Hurricane Planning Commission Meeting Agenda

February 27, 2025
6:00 PM

Agenda Date:	02/27/2025 - Planning Commission
Application Number:	ZC24-07 PSP24-21
Type of Application:	Zone Change and Preliminary Site Plan
Action Type:	Legislative
Applicant:	317 Sycamore LLC
Agent:	Brixton Call
Request:	Approval of a Zone Change approval from NC/PDO to R1-8/PDO.
Location:	2230 W 600 N
Zoning:	Neighborhood Commercial NC with a Planned Development Overlay (NC/PDO)
General Plan Map:	Planned Community
Recommendation:	Table
Report Prepared by:	Fred Resch III/Gary Cupp

**PROPOSED
SITE PLAN**

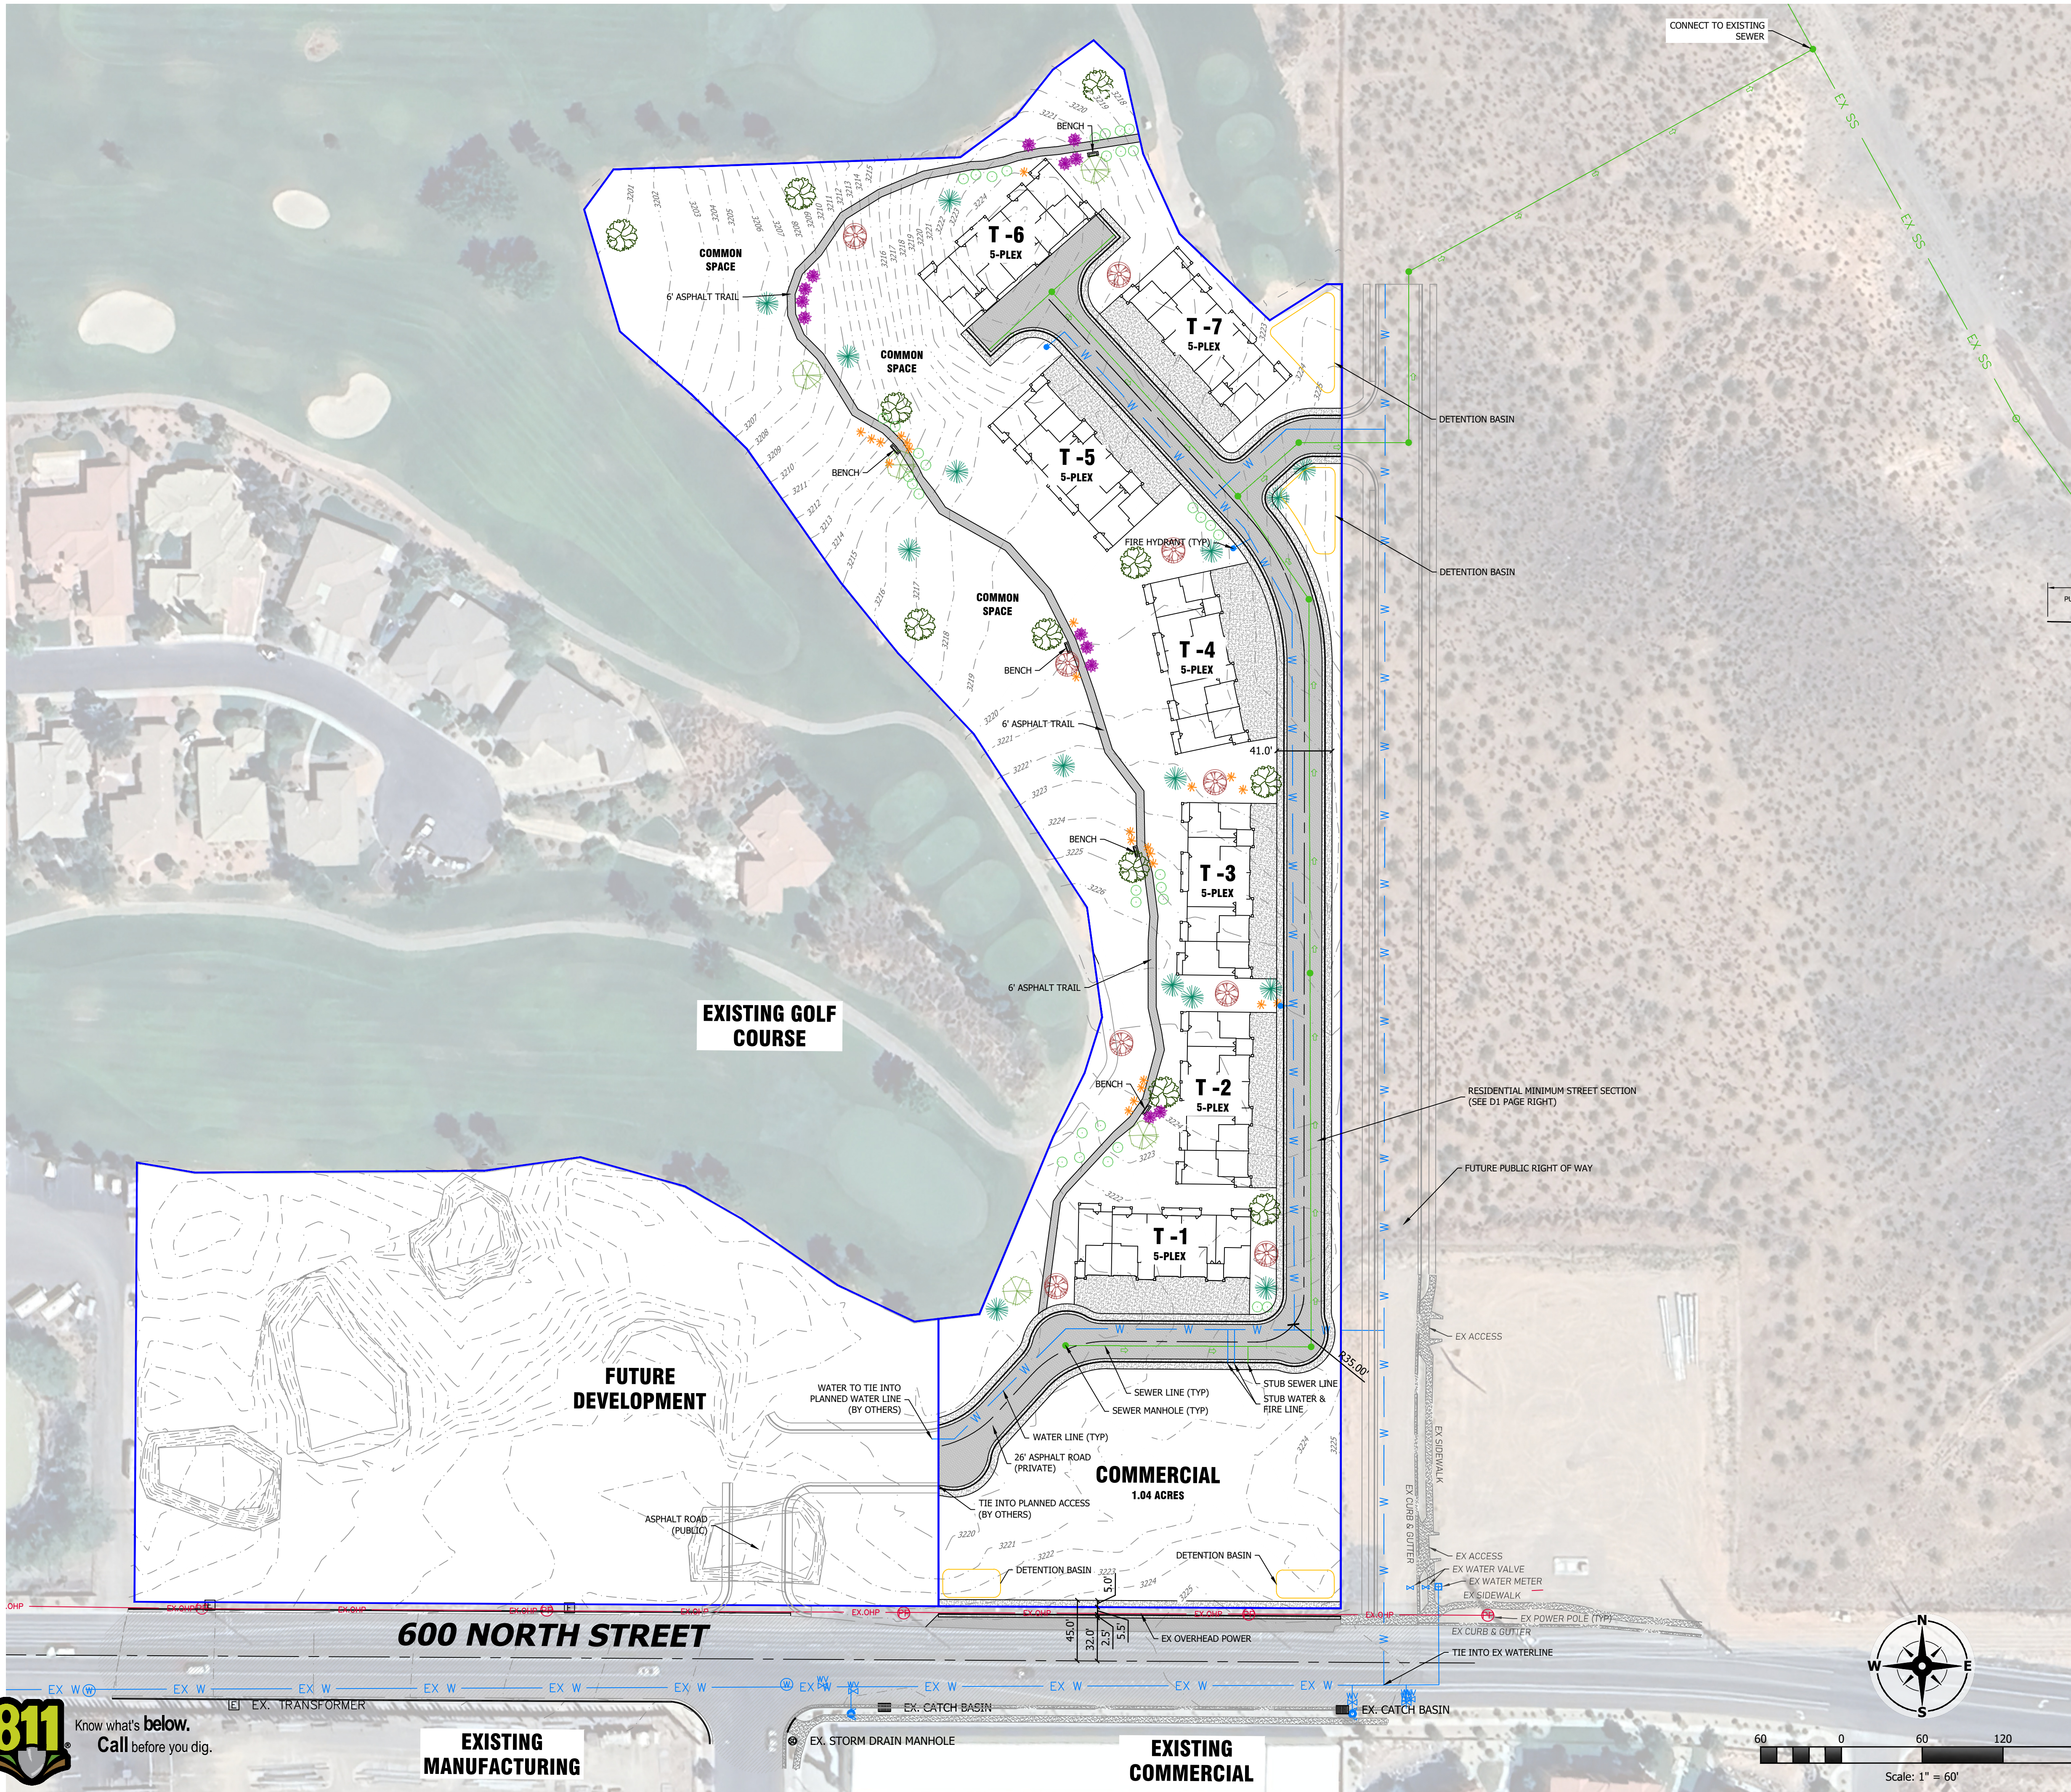
Public Works: Would need to acquire and develop the road to the east labeled Future Public Right of Way for second access. Need to provide a water loop. Interior road does not meet current Hurricane City specifications, private roads need to meet current standards.

Power: Construction plans need to show the transmission line easement on 600N. Power dept also has minimum setback requirements along a transmission line/ this is a NEC mandated code. Block walls shall not come within 10' of the existing power lines. An application for services shall be filled out before construction plans for redlines are allowed to move forward. Application can be found on the Planning and Zoning page of Hurricane City website or requested directly from Hurricane Power. Power has questions about the roadway improvements and also PUE. No medians in the roadway. Power Dept requests that the future ROW be established and dedicated before construction begins, also all roadway improvement be finished at final acceptance. Power dept will require power lines to be established inside the PUE along the said (future roadway).

Engineering: The depicted plan is dependent on neighboring property owners. The applicant must present agreement(s) specifying the arrangement(s) they've made with their neighbors when the preliminary plat application is submitted (HCC 10-39-7(c)(10)). Water looping (HCS 3.6.4 & 3.6.8.2), the sewer connection (crosses Toquerville Enterprises property [see also ACSSD standard 1.2.5(A)]), and access challenges (future public right of way on the plan's east side is not a master planned road and it's owned by Toquerville Enterprises, see also HCS 3.2.4.2(k)) cannot be resolved without neighbors' participation/consent. Where much of the required infrastructure relies on neighboring property owners', engineering would recommend requiring said agreement(s) before granting the zone change. Existing conditions must be accurately modeled to be properly considered (HCC 10-7-10(d)(2)) this plan fails to depict the existing Hurricane City Power substation site (parcel H-3-1-28-3303) and the existing curb, gutter, sidewalk and accesses associated with it. Intersection spacing along the future public right of way can't be checked (see HCS 3.2.4.3 and the Transportation Master Plan section 9.3.2). Private streets must be public and meet Hurricane City standards.

1. **Density:** The proposed density is 4.45 units per acre which meets R1-8/PDO standards. The site plan says 5.22 units per acre however they are allowed to count the commercial area acreage

4. HCC 10-23-9(l)(1) specifies, "all streets shall be public streets and shall be established according to public street standards adopted by the city." The City Council can approve a modified cross section, but that should be requested by the applicant.

5. Staff would recommend that, if approved, a new preliminary site plan addressing staff and JUC comments be provided.

Recommendation: The Planning Commission should review the site plan and the zone change based on standards within the Hurricane City Code and consider any public comments received in the public hearing. Staff recommends tabling unless finalized contracts and cooperation agreements have been received, in which case staff would support the Planning Commission making a recommendation to the City Council to approve the zone change subject to staff and JUC comments and provision of an updated site addressing staff comments.

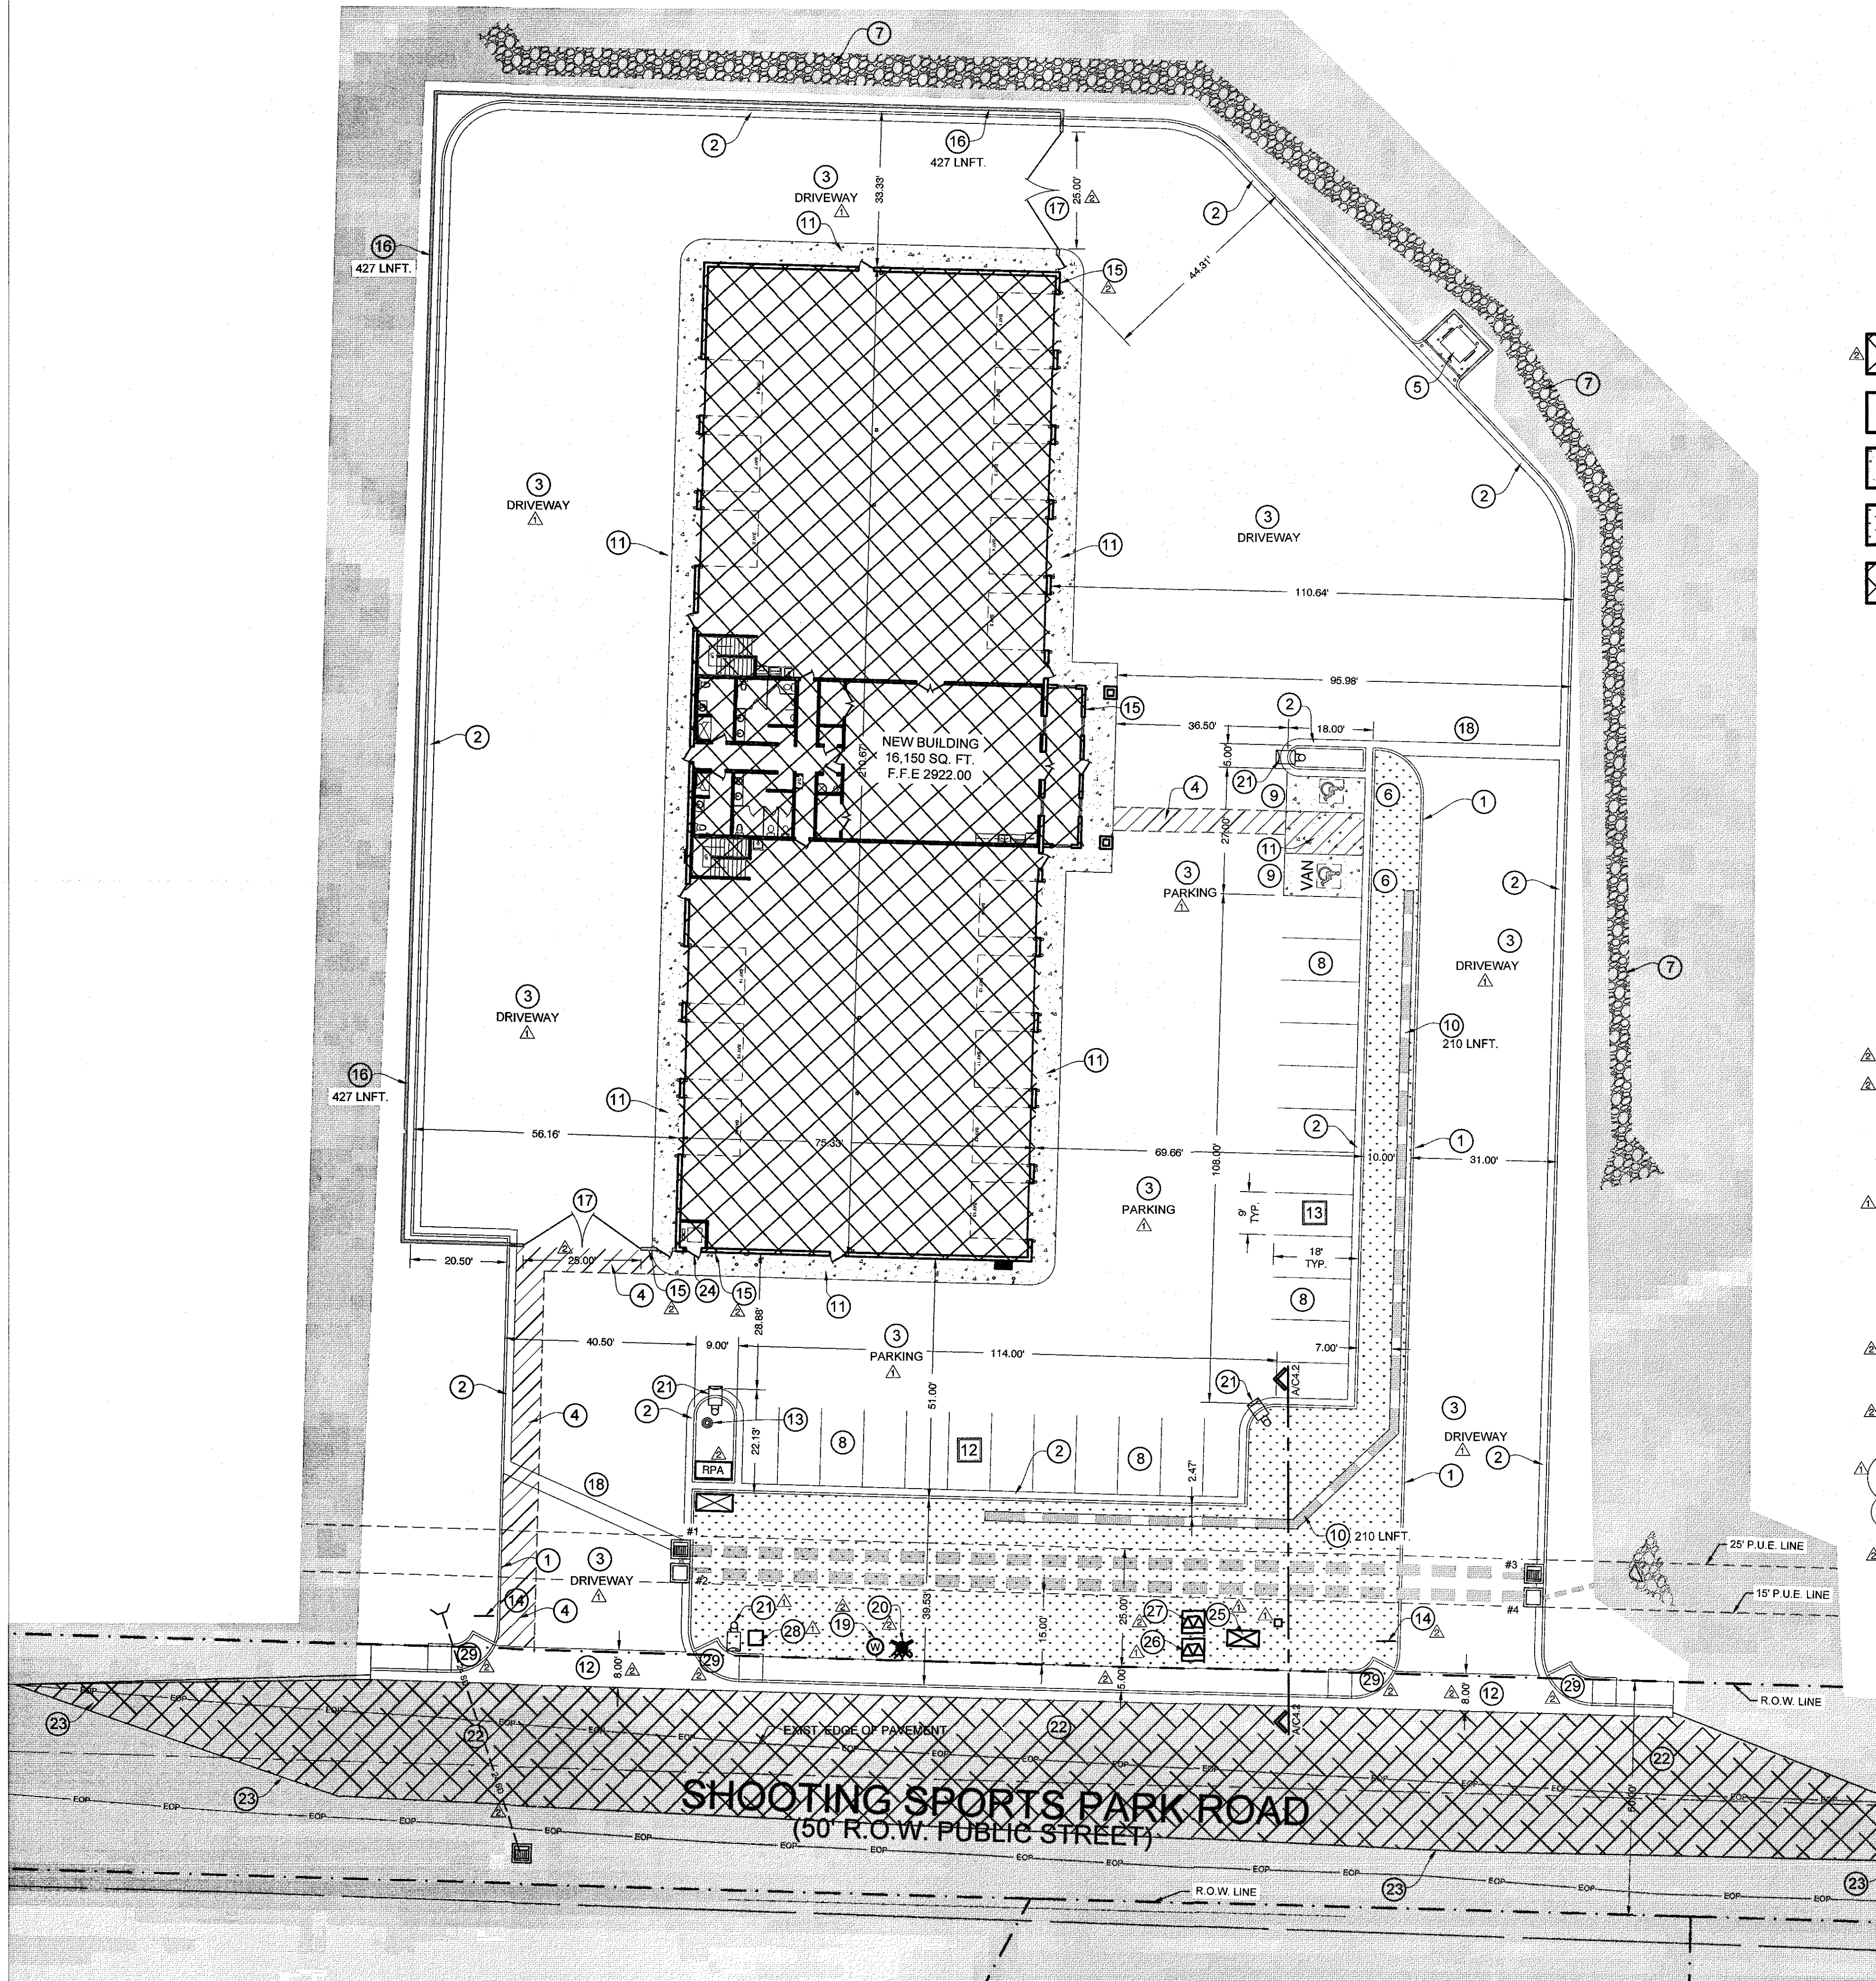
3. **Landscaping:** A landscaping plan has been provided that meets the standards of HCC Chapter 10-32 in terms of the amount of landscaped area and the number of plantings.

4. **Building Elevations:** Building elevations have been provided. The building will be 23', which meets the height requirement of the PF zoning. The building will look generally similar to other county facilities in the area.
5. **Outdoor Lighting:** An outdoor lighting plan has been provided. The applicant will need to ensure that the installed lighting does not exceed 4000K (HCC 10-33-7).

Recommendation: The Planning Commission should review the application based on standards within the Hurricane City Code. Staff recommends approval subject to staff and JUC comments.
